DEVIATION REQUEST AND DECISION FORM

Project Name :	Monument Ridge East Filing No. 1	SF2514
Schedule No.(s) :	7102200006, 7102200008, 7102200010, 7102200013, 7102201001 7102201014	
Legal Description:	See attached

A deviation from the standards of or in Section **11.2.2 Detention Facility Construction** of the Drainage Criteria Manual (DCM) is requested.

MONUMENT RIDGE EAST
FILING NO. 1
POND DETAIL PLANS
- POND 4 - [PVT]

POND MAINTENANCE ACCESS DETAIL
SCALE: N.T.S.

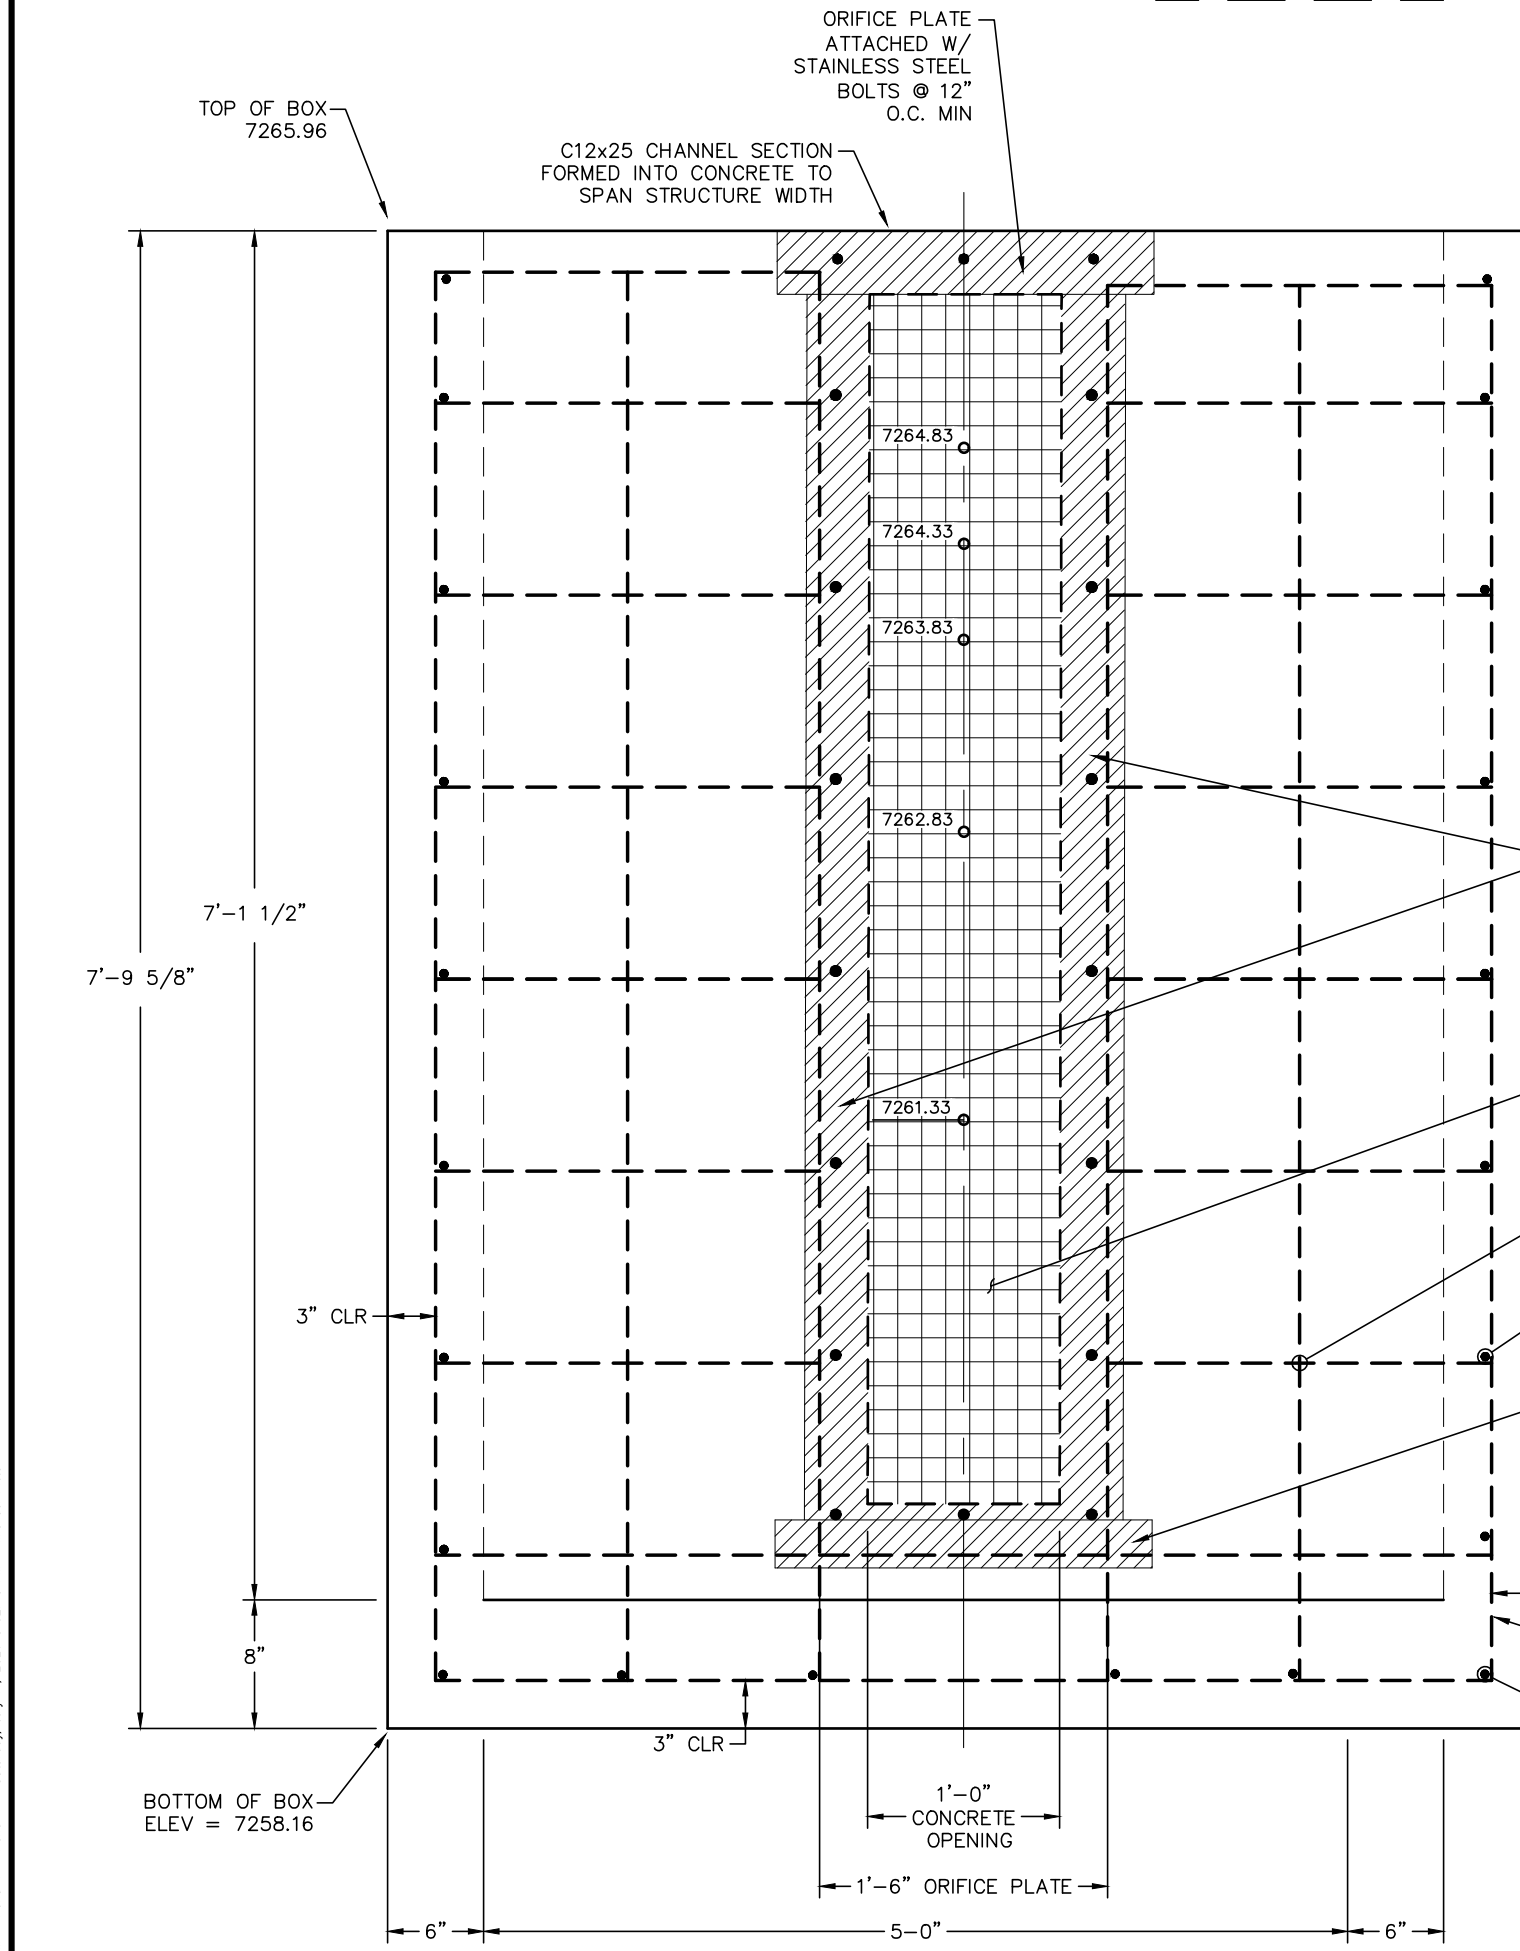
Section 11.2.2. Detention Facility Construction, specifically the grade of the access road from a public roadway to the bottom of the pond. The section specifies a maximum grade of 12%.

Space constraints within the subdivision layout necessitate the request. The request is specific to Pond #4 only. A balance between detention volume, the space required for the pond, and the adjacent improvements as well as a jurisdiction wetland has resulted in constraints on normal access standards.

The request is to allow a 10% slope for the access road. All other criteria will be met, width, etc. The height the access road that needs to be traversed is 7 feet. This can be easily accomplished with the equipment needed to maintain the detention facility. No regular highway vehicle is needed or expected to use this access for maintenance purposes.

There are many facilities with limited or no vehicular access for maintenance. Pedestrian access is provided for periodic maintenance. Construction equipment, skid steer, etc. can manage the proposed slope easily if needed for slope repairs, carrying other implements and parts for structures as needed.
